# **EXHIBIT D-1**

## **DRAWINGS AV0001 – AV6103**

**RFP No. 901516 – East County Hall  
of Justice BDA & DAS**

EAST COUNTY HALL OF JUSTICE

AV2112

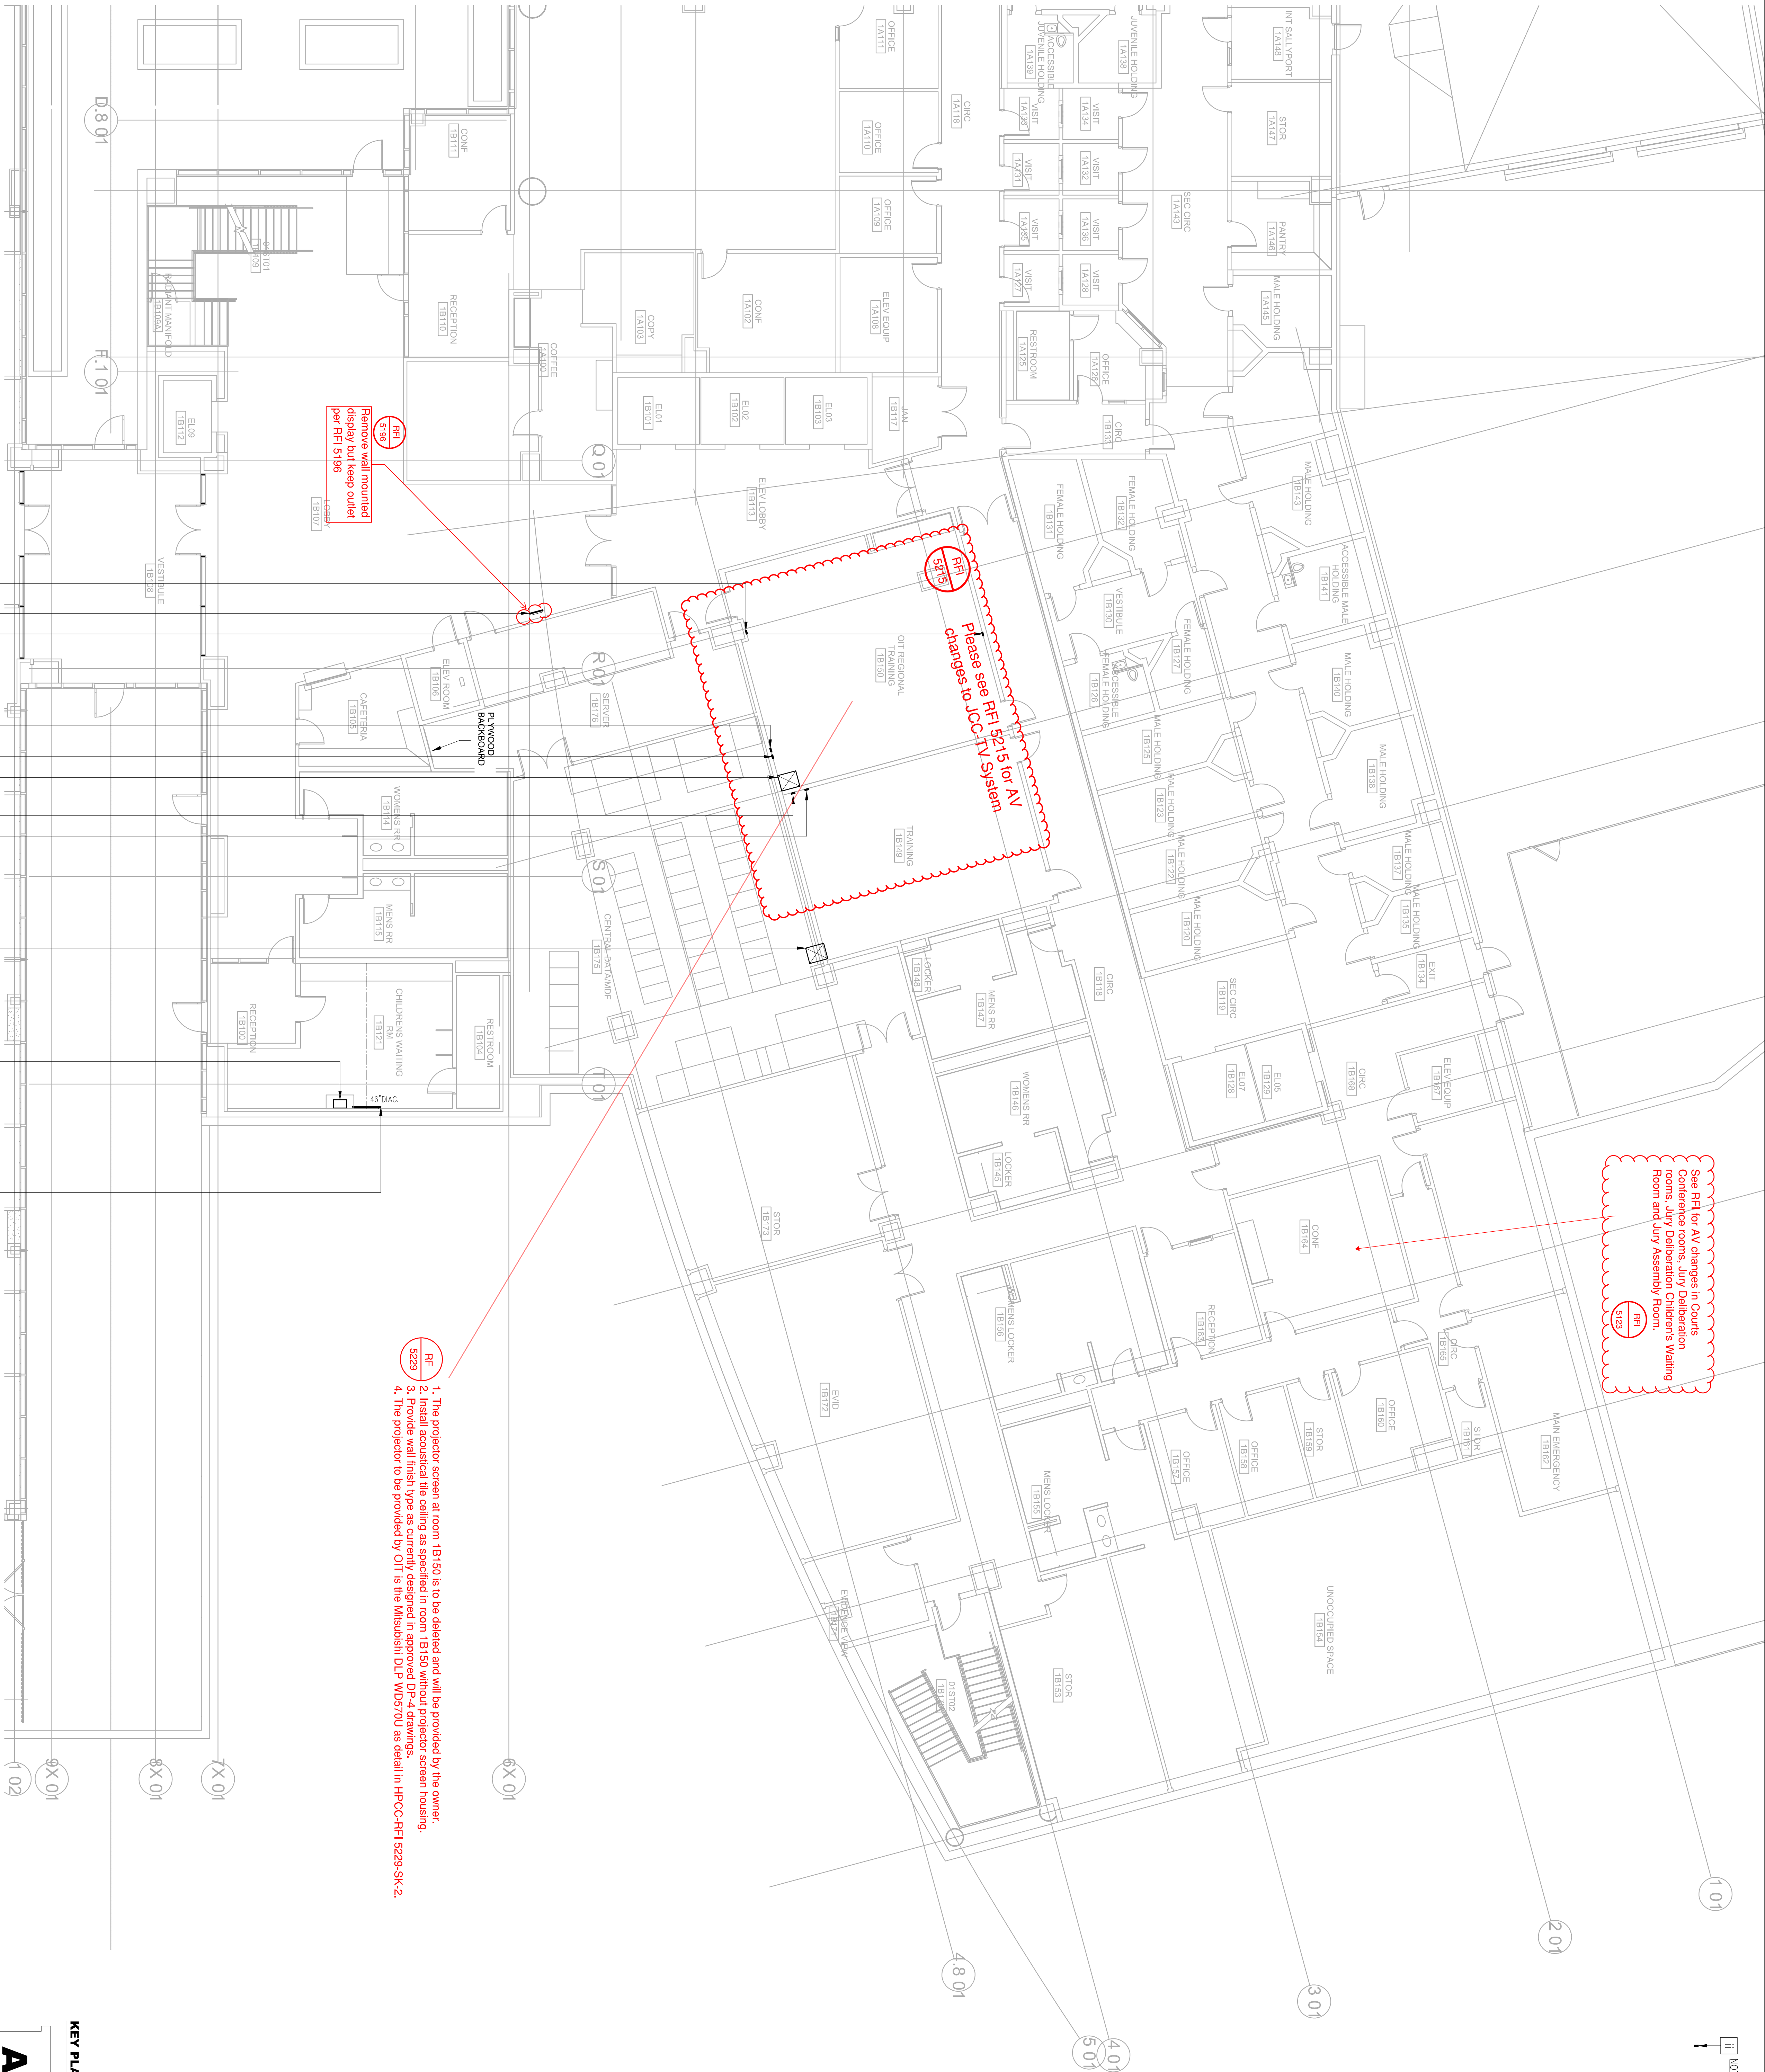
Product Data and mounting heights confirmed in RFI 5196

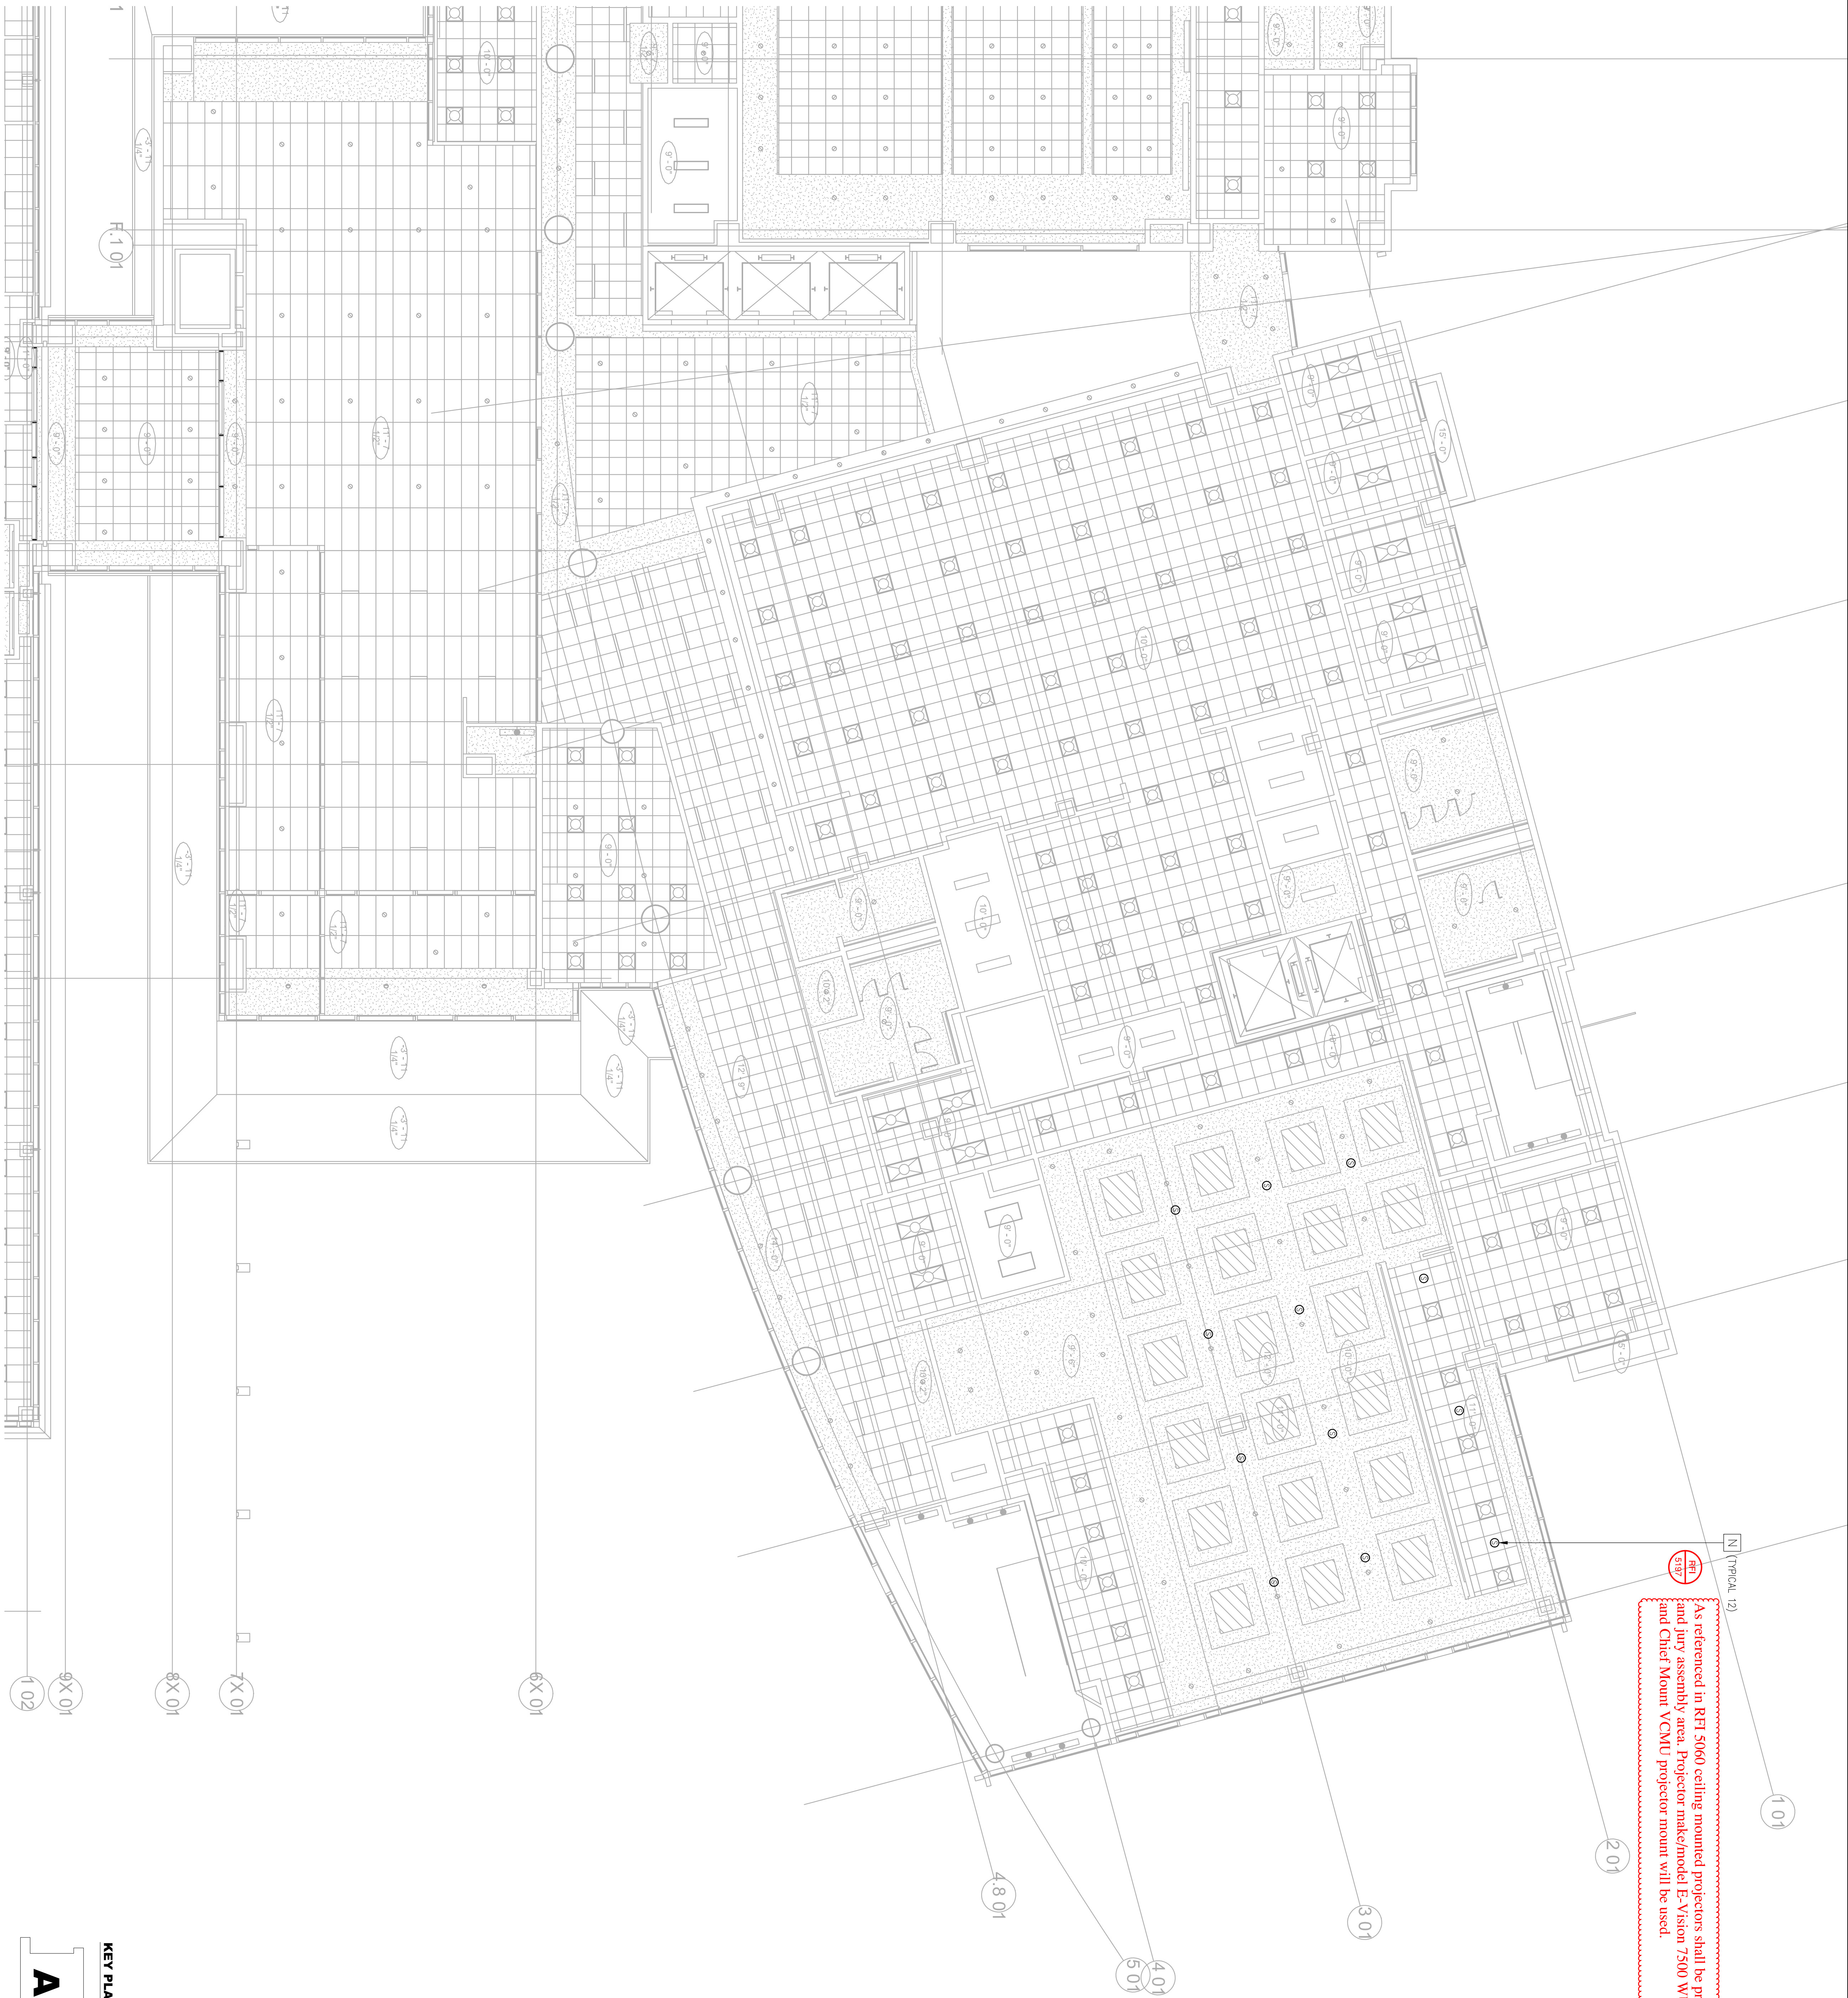
As referenced in RFI 5060 ceiling mounted projectors shall be provided in all 13 courtrooms and jury assembly area. Projector make/model E-Vision 7500 WUXGA 3D Digital Projector and Chief Mount VCMU projector mount will be used.

AV3123

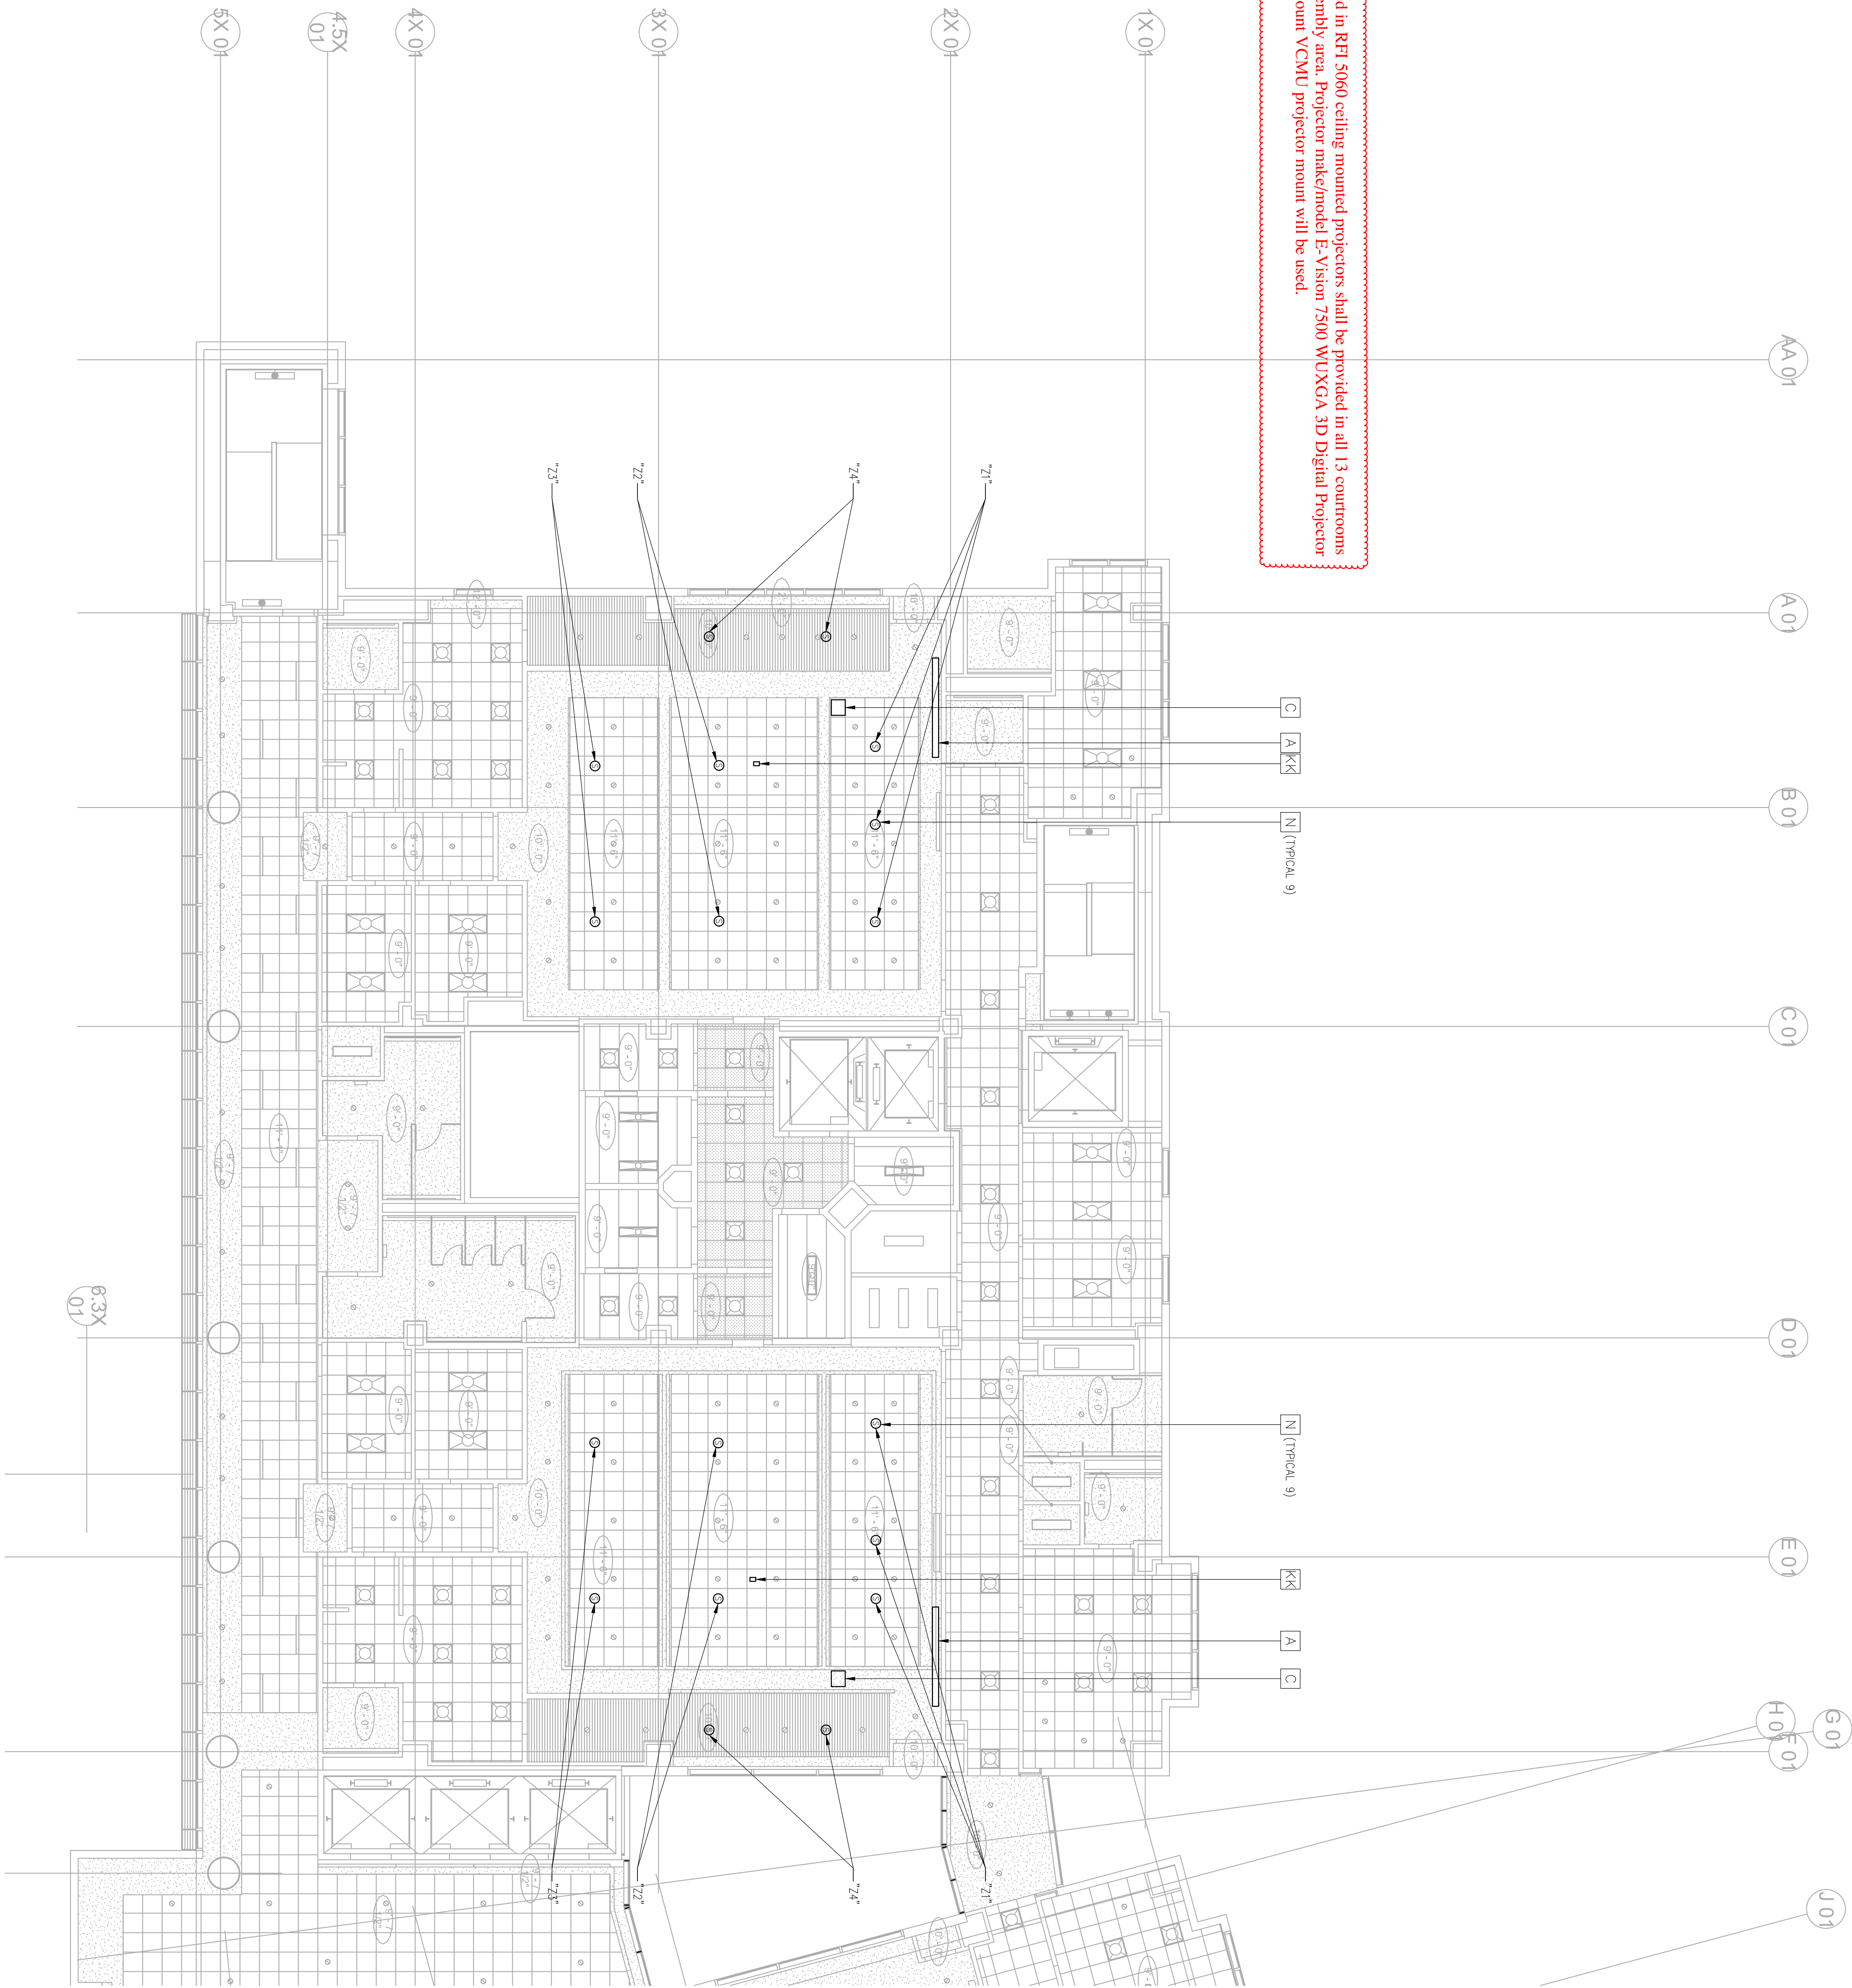
As referenced in RFI 5060 ceiling mounted projectors shall be provided in all 13 courtrooms and jury assembly area. Projector make/model E-Vision 7300 WUXGA 3D Digital Projector and Chief Mount VCMU projector mount will be used.
